Appendix D – Landscape Design changes

College Of Fine Arts UNSW

Landscape Design Changes
February 2011
Site Image Landscape Architects

II. Previous Landscape Plan (EDAW / AECOM), indicating changes locations

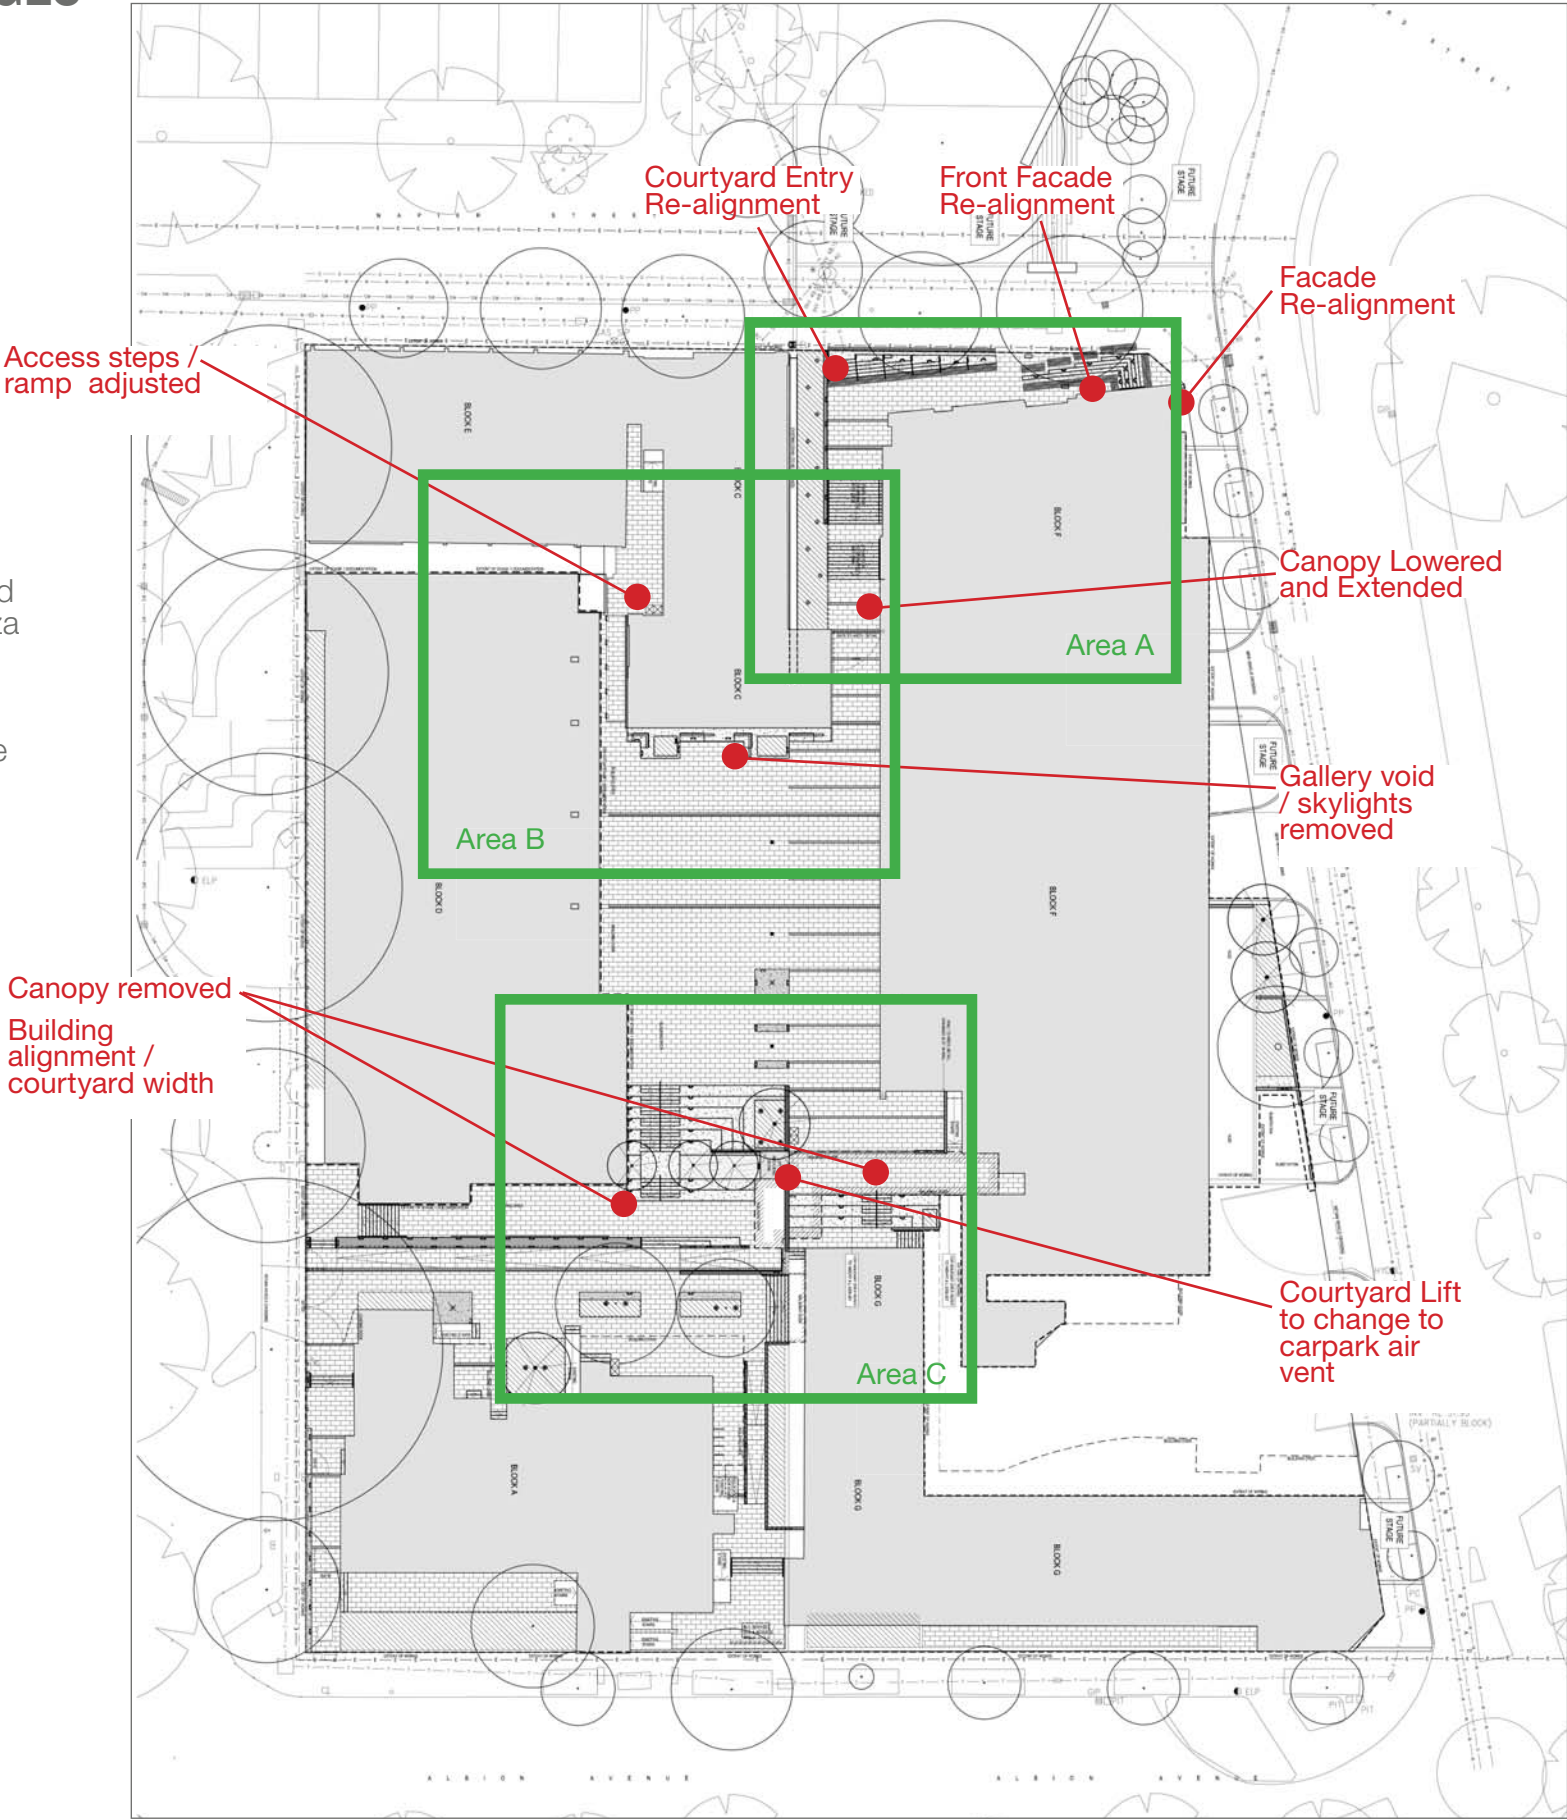
The adjacent EDAW / AECOM plan is annotated with landscape related architectural / building changes as proposed in the Architectus related Section 75W documentation.

The boxed areas noted A, B & C adjacent highlight the detailed areas illustrated in the following pages.

We note that there has been a seperate application relating to the adjusted position of Building D, with a narrow landscaped strip adjacent to the plaza open space to the West.

III. Proposed landscape design changes, indicating areas A1, A2, A3

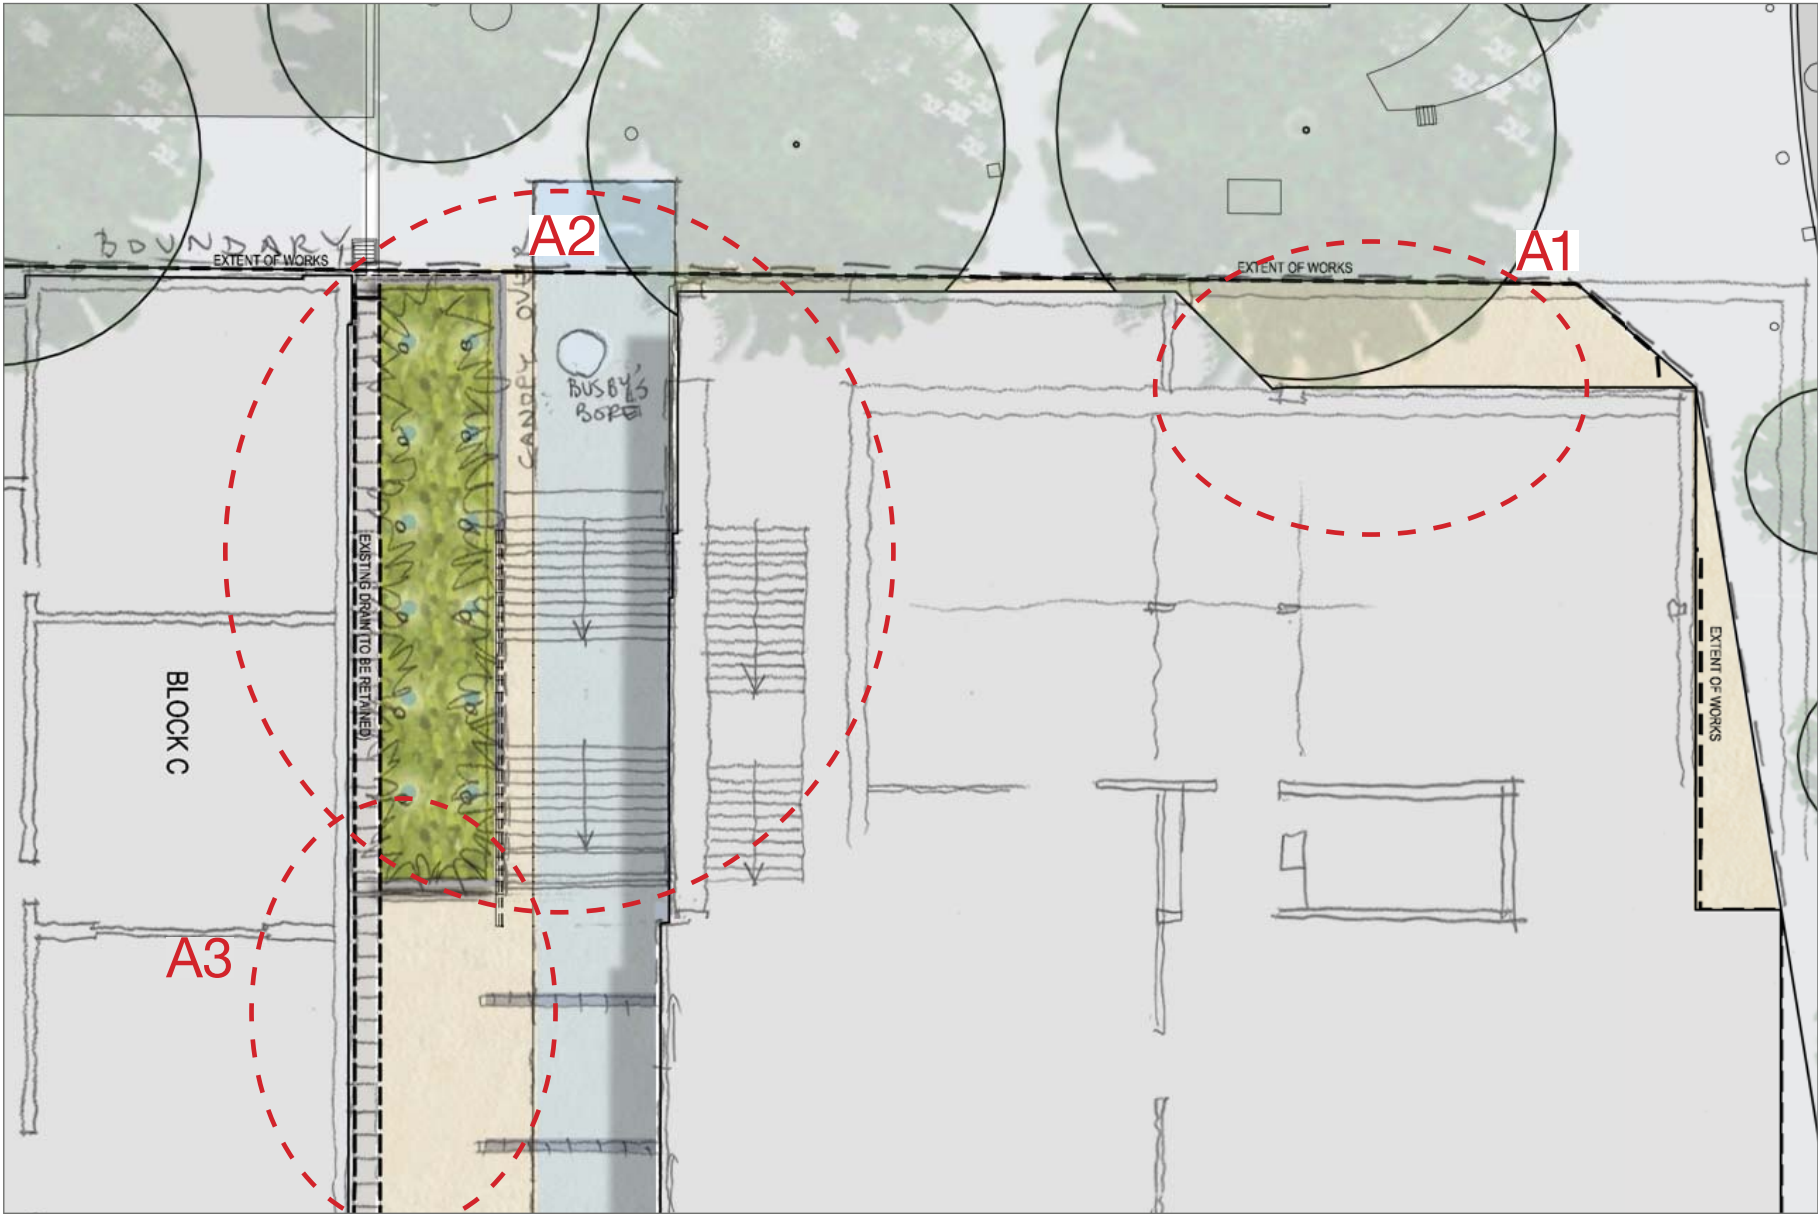
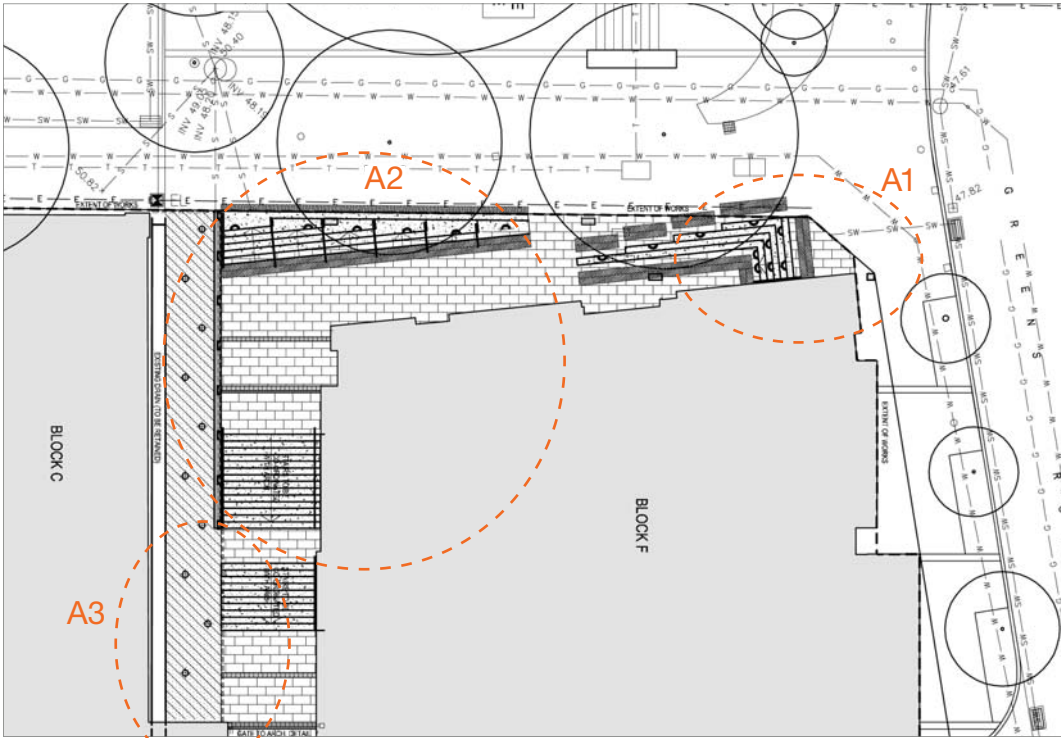
Redesign of the main facade addressing Greens Road / Oxford Street changed the access requirements. The angled steps were changed to match the new facade alignment. New stair arrangement eliminates the 'down and then up' level changes when entering from the street. This assists the general drainage strategy for open space with emergency overland water flow able to flow through this area.

The Galley entry and arrangement adjustments relate more strongly to the streetscape.

The landscape adjacent the main stair is retained, along with the heritage drain, and Busby's Bore access manhole.

AREA A1:
The new design has a simple relationship to the street.

AREA A2:
The stairway and boundary interface has changed in order to reinforce this as a major site entry and address. The 'down and then up' nature of previous stair arrangement has been simplified to be 2 flights of stairs up to the main courtyard. The external stairs strongly relate to adjacent internal gallery stairs, increasing the visual scale of the level change. The 'Heritage' drain adjacent to Block C is retained in planter, and will have Bamboo (uplit) to create vertical landscape to compliment the entry stairway. Keeping the levels of the drain, the planter is at a lower level, creating an alcove space that will maintain general visual access to the foundation wall to Block C, noted as having heritage qualities. Rounded 'river rock' in the planter will provide a feature ground plane treatment.

AREA A3:
For the area above the stair , the 'Heritage drain' is to be salvaged and reinstated into the paving at the upper level, generally in the same plan location. If the units prove to be unsuitable, then a suitable 'marker' pavement will be selected to indicate the previous alignment / continuation of the drain. A handrail at this location is of course provided to provide safety against the level change to the lower level planter.

The pavement banding arrangement continues from the main courtyard space to the South into landing area above the stair, but with a reduced width so that the banding does not interface directly with the Heritage Drain.

V. Proposed landscape design changes, indicating areas B1, B2, B3

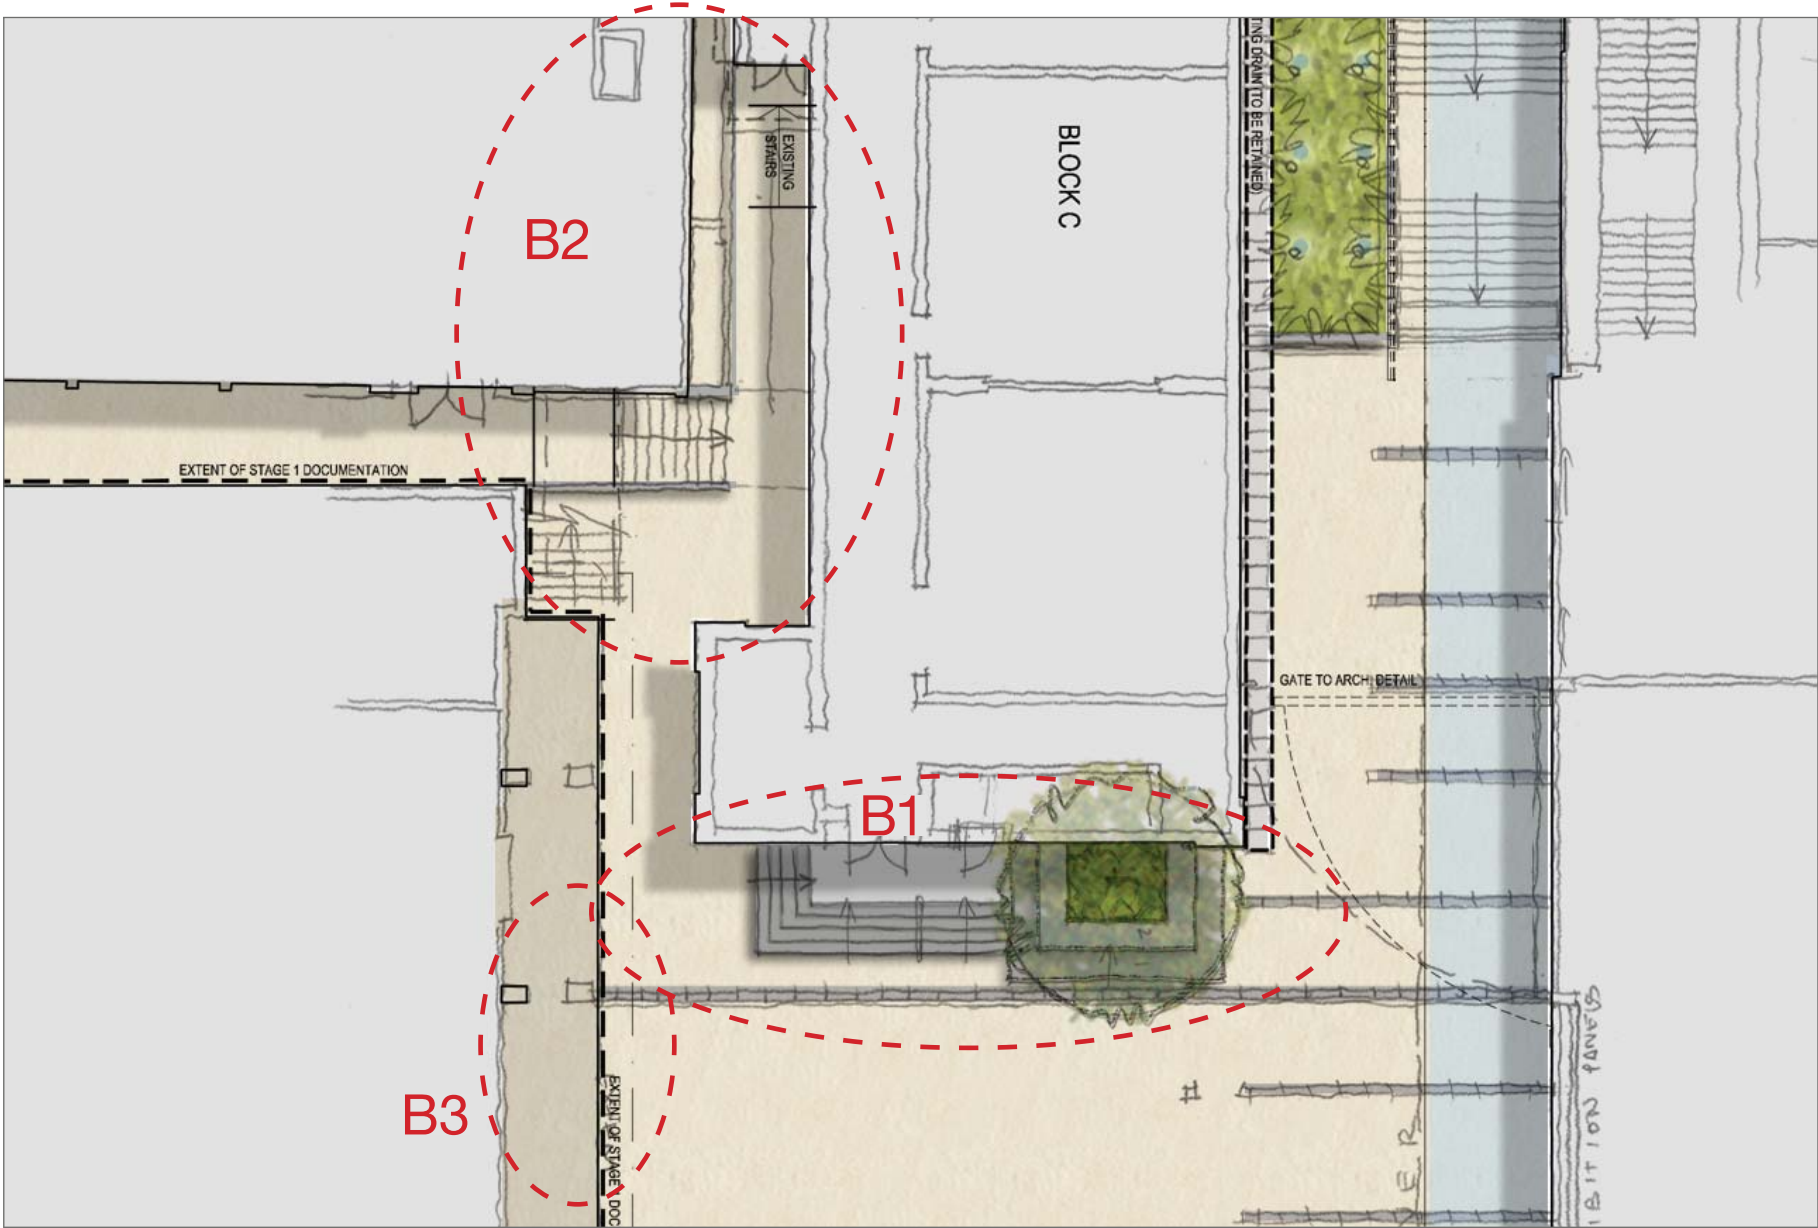
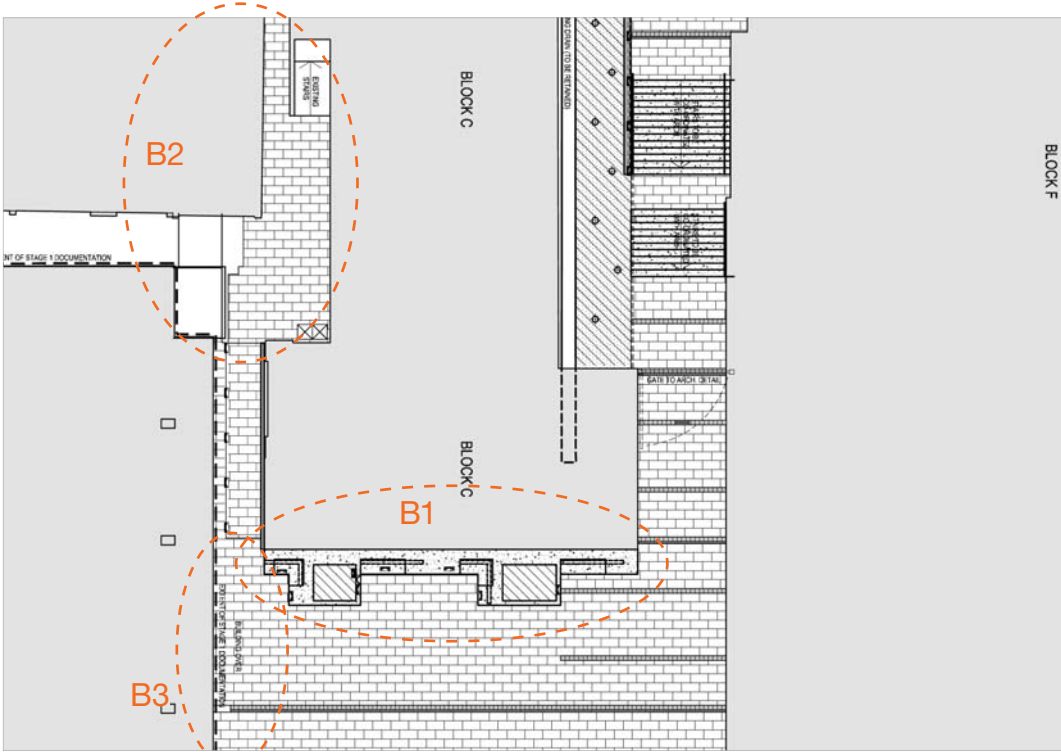
GENERAL:
Block C has been reduced in length, and the access stair / ramps, and link to the 'breezeway' extending to the west are all adjusted to suit. The Skylights to the end of Building C have been removed from the design.

- AREA B1:**
Increased pavement to this area.
- New concrete Bleachers/benches (2 levels) with feature Tree in planter at upper bench level and also new stairs to the entrance to Block C adjacent to the Bleacher/benches and Tree planter.
- AREA B2:**
Adjusted stairs and ramp.
- AREA B3:**
Building alignment results in narrowing of the central plaza pavement. This is offset by the increase of the plaza area towards Building C.
